Tennessee Valley Authority, 1101 Market Street, Chattanooga, Tennessee 37402

CNL-15-134

Watts Bar Nuclear Plant, Unit 2  
Construction Permit No. CPPR-92  
NRC Docket No. 50-391

Subject: **Watts Bar Nuclear Plant Unit 2 – Submittal of Developmental and Final Revision J of the Technical Specification & Technical Specification Bases, and Developmental and Final Revision E of the Technical Requirements Manual & Technical Requirements Manual Bases**

~~FIGURE 3.7.3-1~~

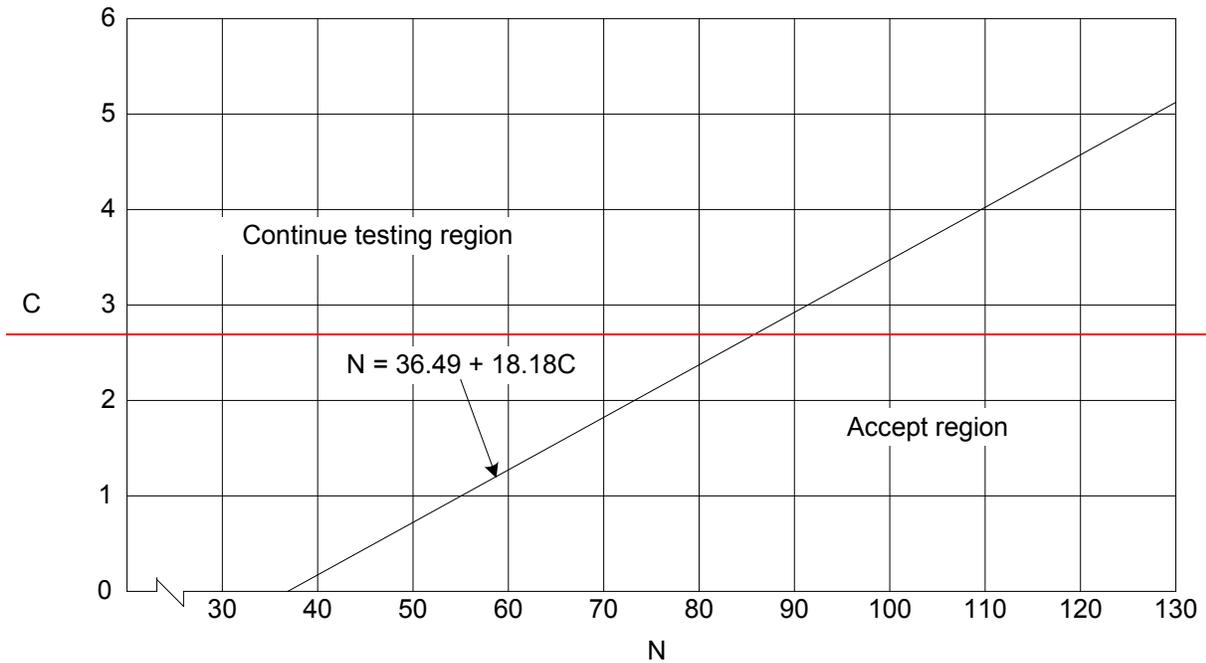
- ~~1. An initial representative sample of 37 mechanical snubbers shall be functionally tested in accordance with Figure 3.7.3-1. For each mechanical snubber type which does not meet the functional test acceptance criteria of Table 3.7.3-5, another sample of at least 19 snubbers shall be tested. The results from this sample plan shall be plotted using an "Accept" line which follows the equation  $N = 36.49 + 18.18C$  where "C" is the number of snubbers which do not meet functional test acceptance criteria. If the point plotted falls on or below the "Accept" line, testing of that type of snubber may be terminated. If the point plotted falls above the "Accept" line, testing must continue until the point falls in the "Accept" region or all mechanical snubbers have been tested.~~
-
